# Risk-Informed GSI-191 AADB RAI 3 Response

Document No: ALION-REP-STP-8998-03	Revision: 0	Page <u>1</u> of <u>7</u>
Document Title: STP Risk-Informed GSI-I9I AADB RAI 3 Response		
Project No: STP-8898		
Project Name: STP Risk-Informed GSI-I9I Support		
Client: STP Nuclear Operating Company		
<p>Document Purpose/Summary: Request for additional information 3 (RAI 3) inquired about the potential for pH changes arising from sump acidification through radiolysis of water and plastic sheathing on cabling. This document provides an explanation for variation of calculated pH and experimentally measured pH as well as expected ECCS performance effects. This document is not considered safety-related.</p> <p>This report includes 8 total pages.</p>

**Figure 1: 30 day pH trend of LB [1] and experimental (CHLE [6,7]) systems.**

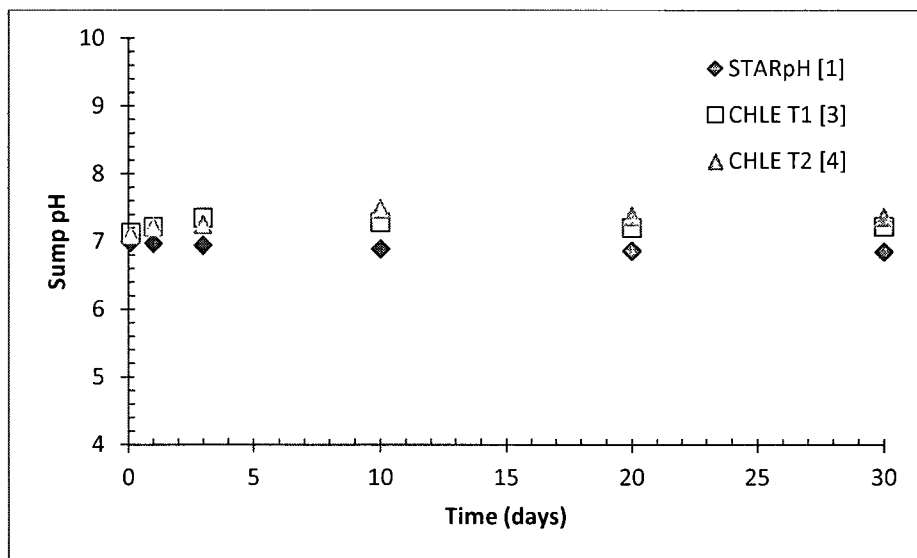
*Discuss the exemption justification as they relate to the effects on sump water pH, radiological consequences, and loss of the containment spray system.*

After complete TSP dissolution, the two inputs resulted in a difference of approximately 0.1 pH units as summarized in Table 1. The higher initial pH in the CHLE tests reflects the different boric acid and TSP concentrations used to define the systems. There is also a small quantity of lithium hydroxide, 0.06 mM Li, added to the CHLE system. The addition of iodine was not considered in either system. During the 30-day analysis, sump pH in both systems changed. As shown in Figure 1, the LB system predicted a decrease in pH of approximately 0.2 pH units resulting from acid addition over 30 days; however the experimental system produced a slight increase in pH of, on average, 0.18 units over 30 days using the same acid addition schedule used in the LB system (Figure 2).
